CITY OF DALLAS LANDMARK COMMISSION

Monday, November 4, 2019
AGENDA

Dallas Power & Light Building CA190-009(LC)
Liz Casso

Request #1 – Proposed Fence CA190-009(LC)

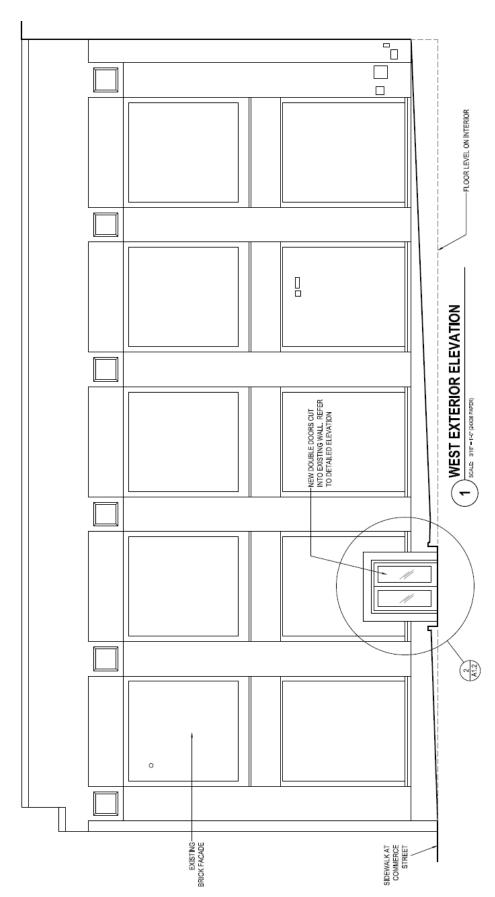
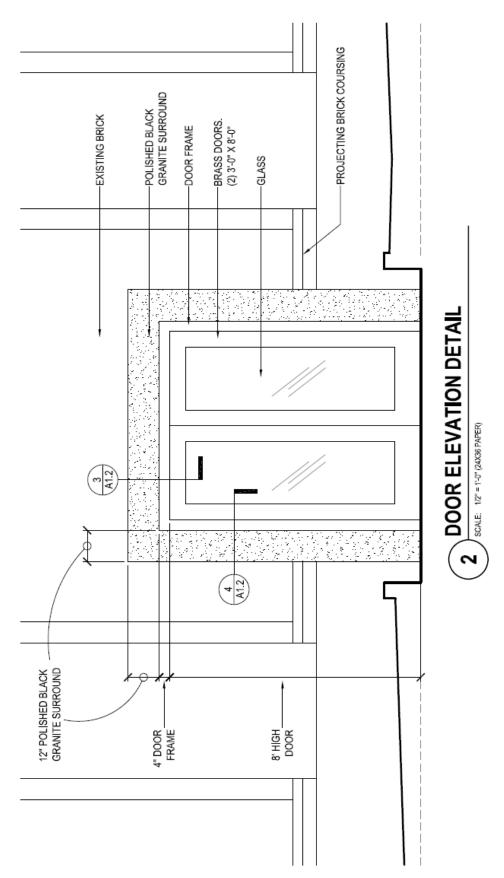
- 1. Install metal fence around courtyard at northwest corner of site.
- 2. Install a new door opening on west elevation.
- 3. Install black granite along the base of structure on the west and north elevations facing the patio.

- 1. Install metal fence around courtyard at northwest corner of site Approve Approve as submitted.
- 2. Install a new door opening on west elevation Approve with conditions Approve as submitted with condition that applicant provide horizontal and vertical sections through doors and frames showing details how granite and frame finish at walls.
- 3. Install black granite along the base of structure on the west and north elevations facing the patio – Approve with conditions - Approve as submitted with condition that applicant provide horizontal and vertical sections through doors and frames showing details how granite and frame finish at walls.

- Install metal fence around courtyard at northwest corner of site – Approve – Approve drawings dated 11/4/19 with the finding the proposed work meets the standards in City Code Section 51A-4.501(g)(6)(C)(i).
- Install a new door opening on west elevation Approve

Reqyest #1 – One-Story Rear Addition to be Removed (highlighted above with yellow arrow)

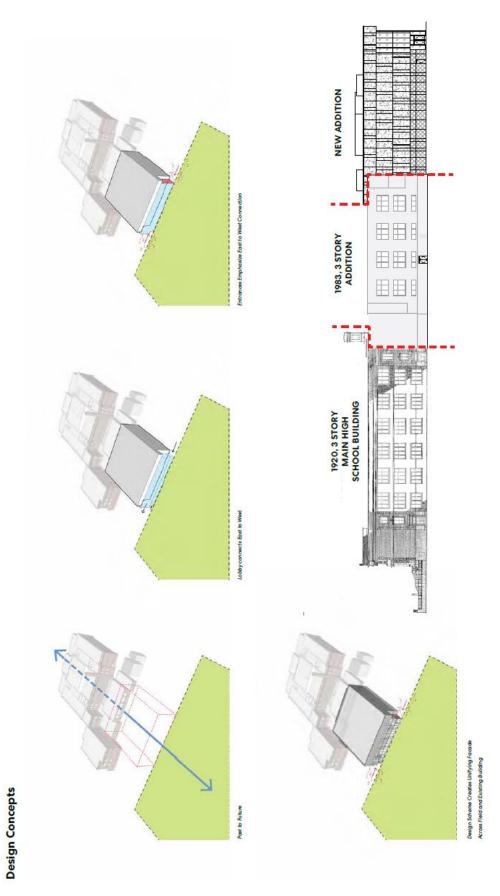
- 1. Remove existing one-story rear addition.
- 2. Construct a storm shelter addition on rear elevation.
- 3. Reconfigure parking lot and building service area, including associated landscaping and metal screening around the new service area.
- 4. Regrade and reconfigure sports field.
- 5. Install new metal fencing.
- 6. Replace existing pole sign in front yard with new electronic marquee sign.

- Remove existing one-story rear addition Approve -Approved as submitted.
- 2. Construct a storm shelter addition on rear elevation Approve Approved as submitted with suggestion that applicant show the facade design studies.
- Reconfigure parking lot and building service area, including associated landscaping and metal screening around the new service area – Approve - Approved as submitted.
- Regrade and reconfigure sports field Approve -Approved as submitted.
- 5. Install new metal fencing Approve Approved as
- Replace existing pole sign in front yard with new electronic marquee sign – Approve – Approved as submitted

1. Remove existing one-story rear addition – Approve – Approve drawings dated 11/4/19 with the finding the

Request #4: Patio

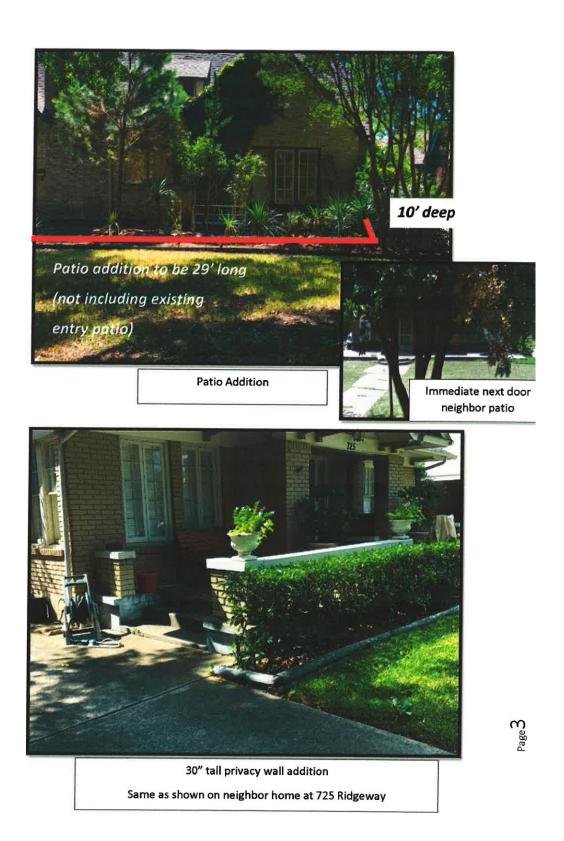
- placement as shown. There are two separate plans. Need to clarify.
- 4. Install patio on front elevation Deny Deny patio wall.
- 5. Remove three windows on front facade and replace with French Doors Deny No additional comments provided.

Request #14: Paint brick

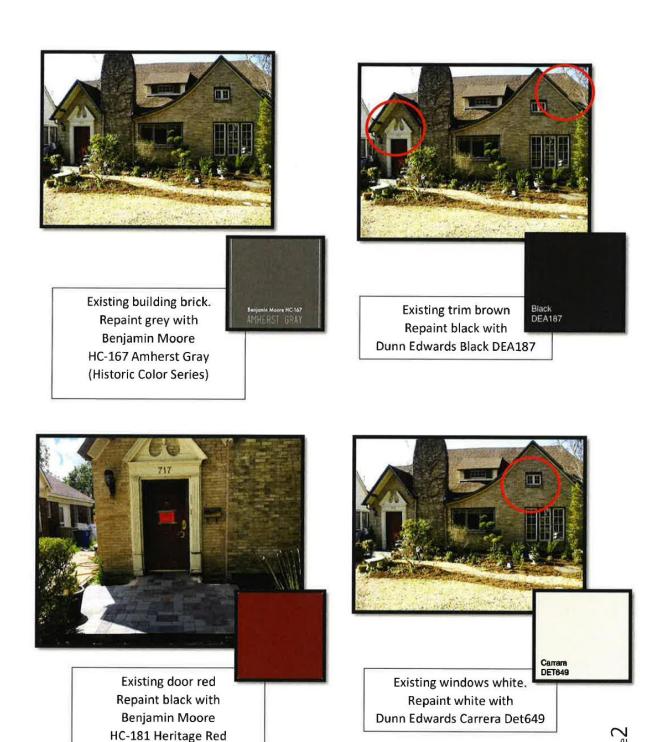
- 13. Install siding on rear and side elevations Deny Plans not appropriate for historic district.
- 14. Paint main structure. Body (brick): Benjamin Moore HC-167 "Amherst Grey;" Trim: Dunn Edwards DEA187 "Black;" Accent 1: Benjamin Moore HC-181 "Heritage Red;" Accent 2: Dunn Edwards DET-649 "Carrara" – Deny - No additional comments provided.

Request #3: Install two new metal flowerbed planters in front yard.

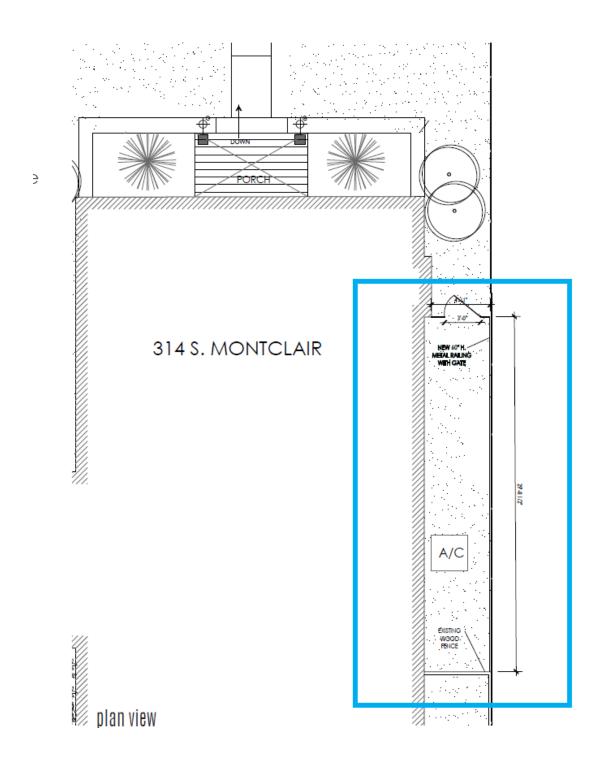
- 2. Enlarge concrete steps at front porch No quorum, comments only Repair concrete steps to original.
- Install two new metal flowerbed planters in front yard. Work initiated without Certificate of Appropriateness - No quorum, comments only - Provide height of new/proposed metal planter.

- 3. Install two new metal flowerbed planters in front yard. Work initiated without Certificate of Appropriateness Denial without Prejudice The proposed work does not meet the standards in City Code Section 51A-4.501(g)(6)(C)(i) because it is inconsistent with the preservation criteria for planter boxes in Section 51P-87.111.(b)(7)(B) that states "Planter boxes must be 36 inches or less in depth" and Section 51P-87.111.(b)(7)(D) that states "Planter boxes must be constructed of brick, natural stone, or smooth-finished concrete that matches or is compatible in texture, color, and style with the main building."

Request #4: Install new wrought iron fence and gate in side yards.

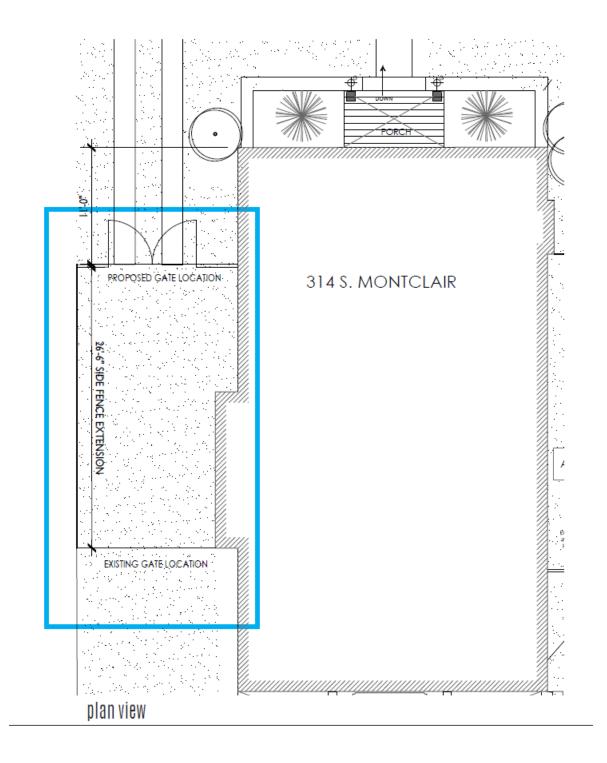
- 4. Install new wrought iron fence and gate in side yard No quorum, comments only Show dimensions of existing fence & A/C unit in relation to proposed new railing.

- 4. Install new wrought iron fence and gate in side yard Approve Approve site plan dated 11/4/19 with the finding the proposed work is consistent with the criteria for fences in the preservation criteria Sections 51P-87.111(b)(2)(C)(ii) with the finding that more screening is needed for an exterior A/C unit and it meets the standards in City Code Section 51A-4.501(g)(6)(C)(i).
